MONTGOMERY COUNTY PLANNING BOARD
 THE MARYLAND-NATIONAL CAPITAL PARK AND PLANNING COMMISSION

MEMORANDUM

REVIEW TYPE: Site Plan Review
CASE #: 820070030
PROJECT NAME: Colesville Road Hilton/Hampton Inn/Homewood Suites
APPLYING FOR: Approval of the Conversion of an Existing Office Building to Hotel
REVIEW BASIS: Division 59-C-6.22 (a). Land Uses in Central Business District Zones

Site Plan: Alternate #3 – Front Entrance Trash Pickup and Delivery

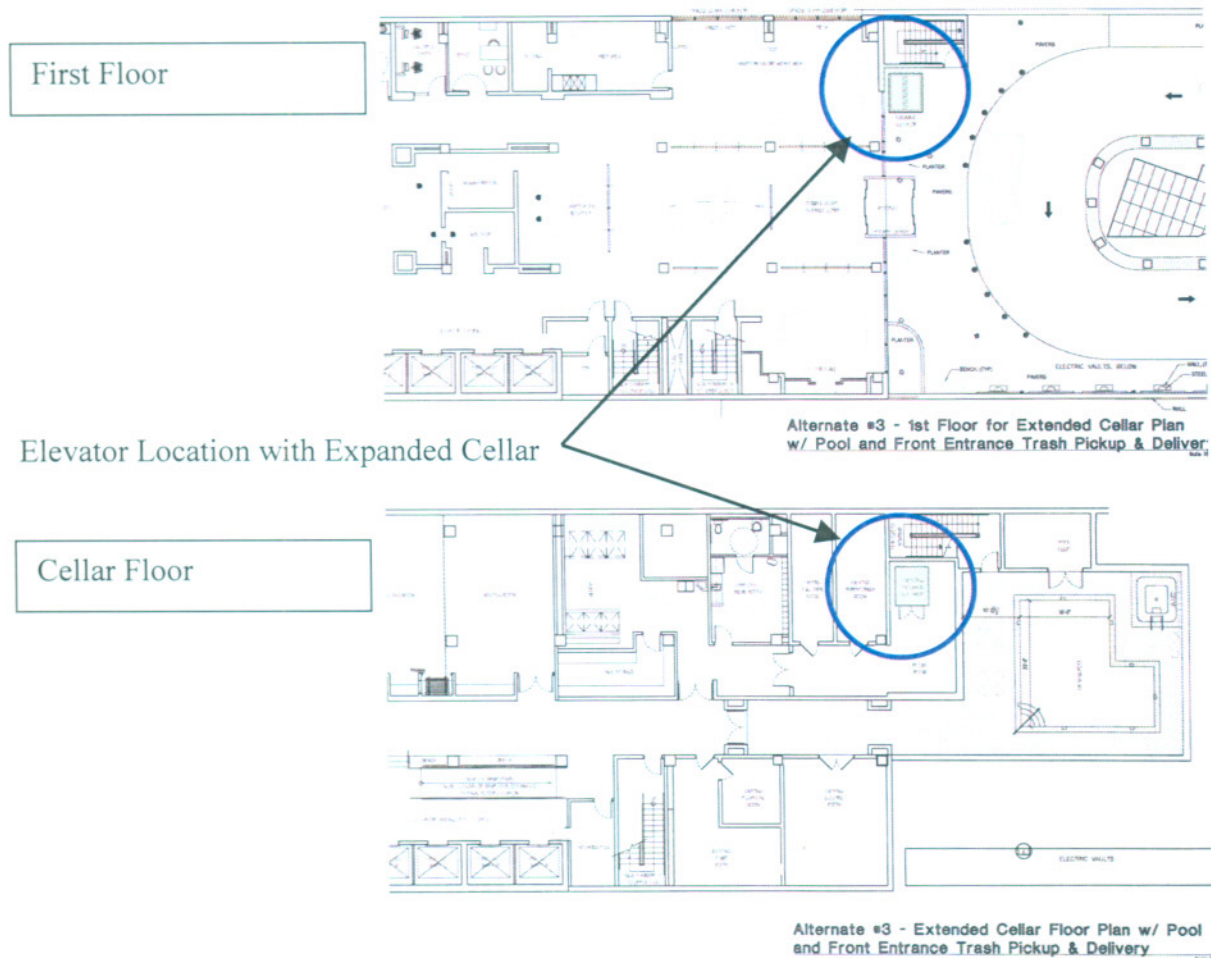
Staff supports and encourages any agreement that would allow deliveries to be made and refuse to be removed from the site via the rear entrance. If this agreement cannot be obtained, use of the front as a means of refuse pickup and delivery will be subject to the conditions in the Transportation section above.

- a. If an agreement for trash pickup and delivery from the rear of the existing building cannot be obtained, the applicant shall renovate the existing building according to 'Alternate #3 – Extended Cellar Floor Plan w/Pool and Front Entrance Trash Pickup and Delivery' as drawn on the architectural plans stamped by the M-NCPPC on January 5, 2007.
- b. If an agreement allowing access to the adjacent Public Garage is obtained, the applicant shall renovate the existing site according to 'Site Plan Options – Public Parking Garage Entrance w/Delivery/Trash Lift' or 'Site Plan Options – Public Parking Garage Entrance Option' consistent with approval of 11.a. above and as drawn on the architectural plans stamped by the M-NCPPC on January 5, 2007.

Site Plan Options: Parking Garage Connection with and without Trash & Delivery Lift

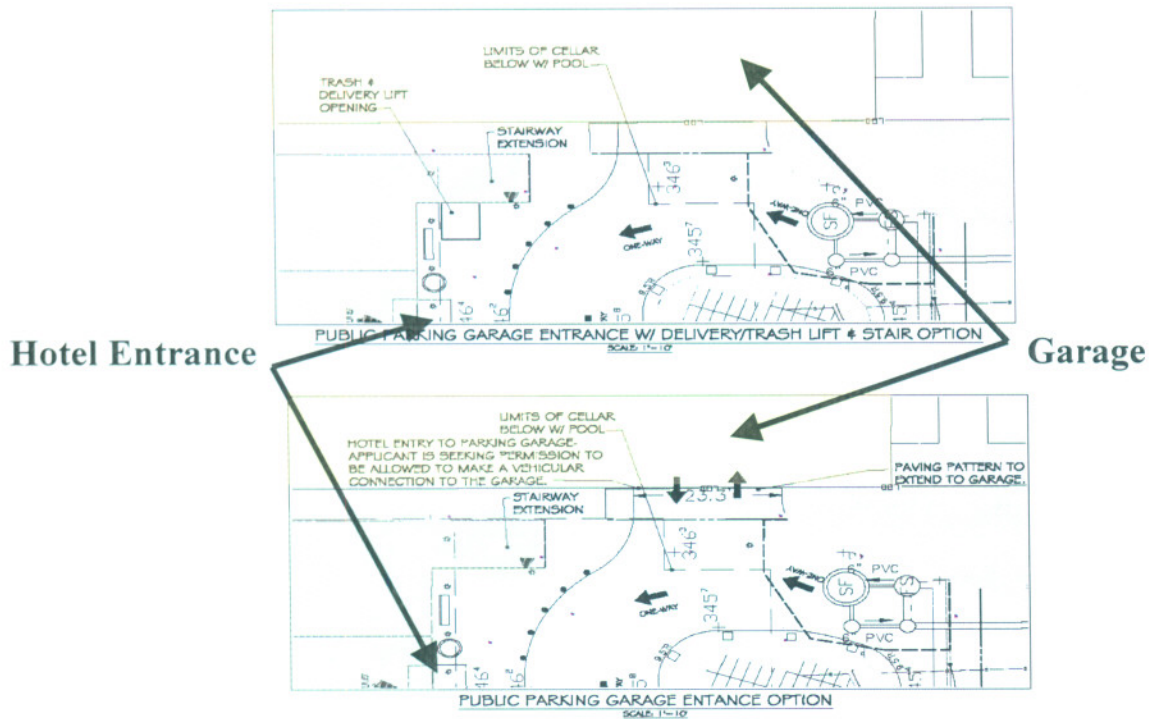
Staff supports and encourages any agreement to construct the vehicular and pedestrian access to the adjacent parking garage. In lieu of this agreement, staff supports the approval of this project with the additional condition noted in the Alternate Site Plan Options section of the Staff Recommendation

The applicant has proposed to alter the site plan as necessary to provide access to the existing adjacent parking garage in concert with the decisions made with respect the rear trash pickup and delivery options, according to the Site Plan Options stamped by the M-NCPPC on January 5, 2007. The options alter the site plan according to which agreements are obtained.
